## RFI

RFI #: E02  
Date: 02/21/2024  
Job: Erdman Cadillac – Cocoa, FL  
PH:

### RESPONSES TO RF# 2 dated February 28, 2024:

**WOOD WALL- HEADER (CORRIDORS)**

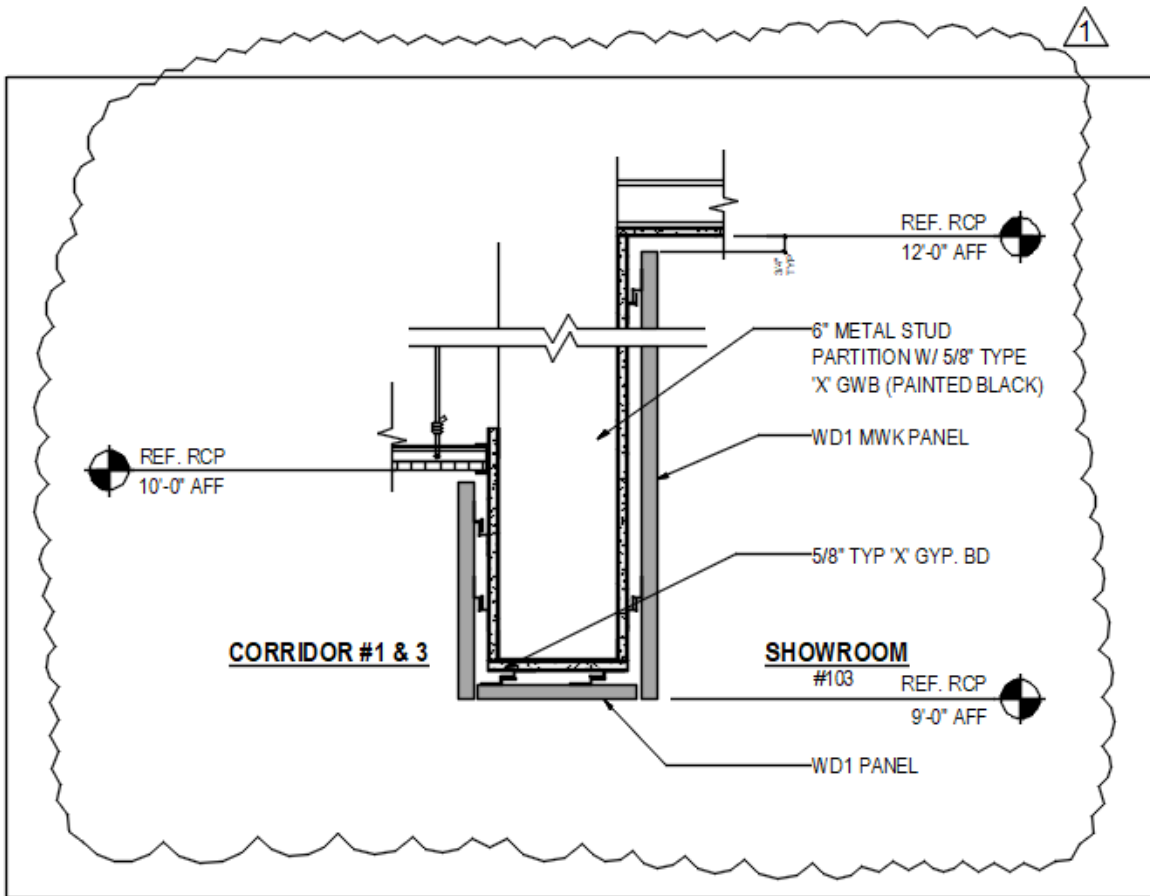
2. Drawing A-411, Det. 5, please issue dimensions of this header and required metal stud sizes. **Sheet A411 is noted as "For Reference Only" and contains standard Cadillac issued drawings. Please refer to the updated Header Section attached to the end of this RFI Response.**
